UNITED STATES PATENT AND TRADEMARK OFFICE

10/791,699

Office Action Summary

DETAILED ACTION

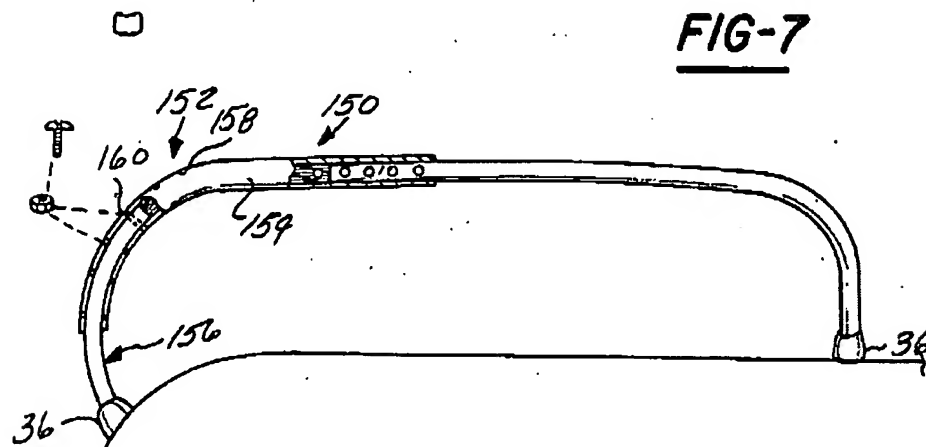
Re 11: Meyers, especially in Figs 1-2 11-12, and 14-15, along with the EAST text searches available in file wrapper copied below from column 5, teach a wheelchair having a front wheel support comprising a curved tube 13 and a curved part 14 with a 1sr portion having identical curvature as the curved tube, and the cross section of the curved part 1st portion allows it to fit inside the curved tube, and a second portion of the curved part has a wheel sear (at 12) such that the curved part 1st portion can be telescopically shifted inside the curved tube providing increased or decreased overlap.

Re 4: There is a load path provided between the curved part and curved tube (at the overlap).

Re 5: The securing arrangement is the locking push button or pin 15A.

Re 7: The 1st portion comprises a section that can be expanded to form a tight fit with respect to the **curved tube**. Note that "can be" only requires that it be physically possible to do this.

Re 8: The 1st portion comprises a section that can be expanded by means of a screw or ring-shaped element. Again, note that "can be" only requires that it be physically possible to do this.

Re 10: There is at least one front wheel support (Fig 1-2).
